# NOTICE OF CHANGE

## IMPLEMENTATION OF TRANSPONDER AIRSPACE AT SIOUX LOOKOUT AIRPORT (CYXL)

### SIOUX LOOKOUT, ONTARIO

### NEW TRANSPONDER AIRSPACE

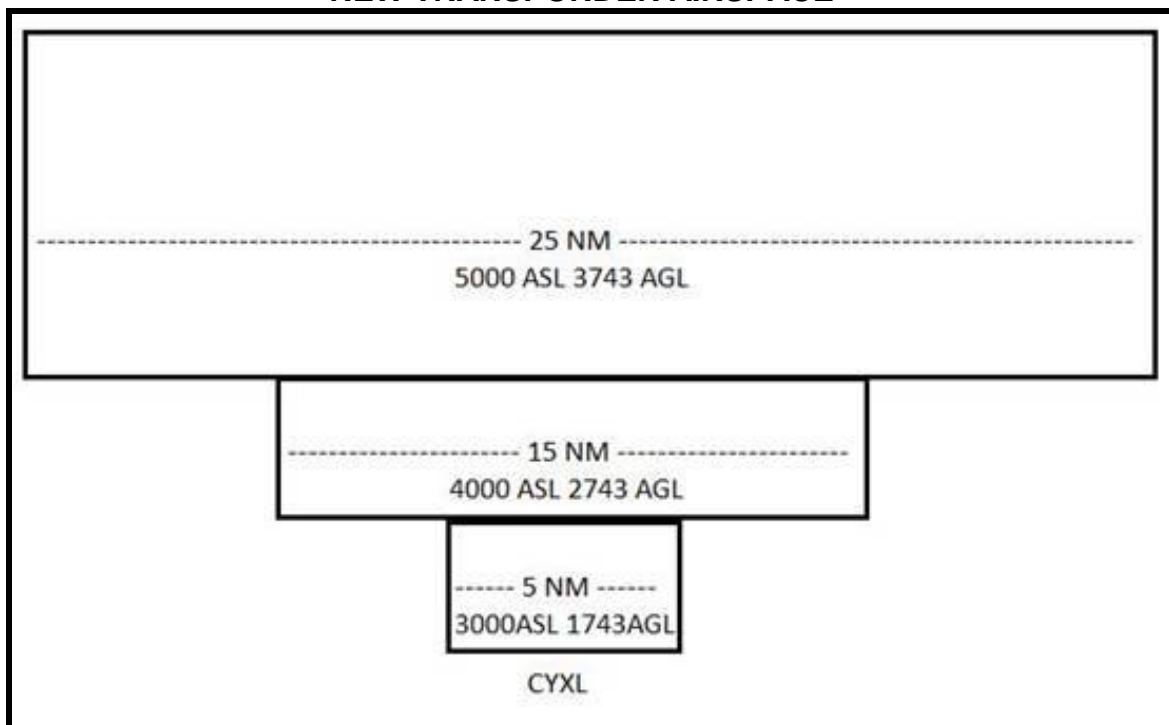
The existing Class E airspace will be designated as transponder airspace at CYXL as follows:

- 3000' ASL (1743' AGL) and above within the 5 NM control zone;
- 4000' ASL (2743' AGL) and above within the 15 NM transition area; and
- 5000' ASL (3743' AGL) and above within 25 NM control area extension.

**This change will take effect on 21 May 2020 at 0901 Coordinated Universal Time (UTC). The appropriate aeronautical publications will be amended.**
